**Reduced Fastener Assemblies
February 2, 2015**

To: Versico's Authorized Contractors

10 Fastener Pattern

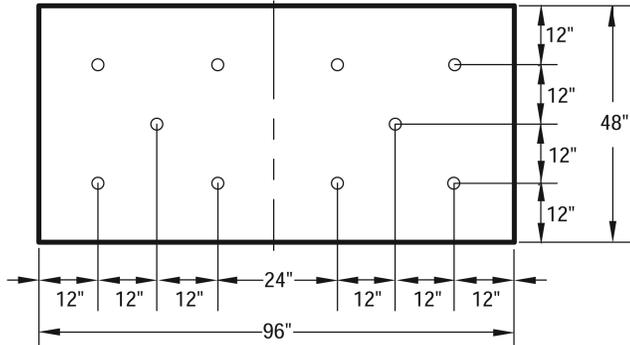
Versico Roofing Systems, in conjunction with USG Roofing Solutions, recently obtained Factory Mutual approvals (RoofNav numbers pending) for reduced fastening requirements for cover boards in fully adhered assemblies. These approvals are **exclusive to Carlisle Construction Materials roof systems** that utilize USG SECUROCK® Gypsum-Fiber Roof Board underneath fully adhered single-ply membranes. The reduced fastening requirements are outlined in the table below:

Product Thickness	FM Rating	Fasteners (existing)	Fasteners (updated)	Fasteners per sq. ft. (updated)
1/4"	FM 1-90	16	10	3.20
3/8"	FM 1-90	16	8	4.00
1/2"	FM 1-90	10	8	4.00
1/2"	FM 1-75	N/A	6	5.33
5/8"	FM 1-90	8	6	5.33
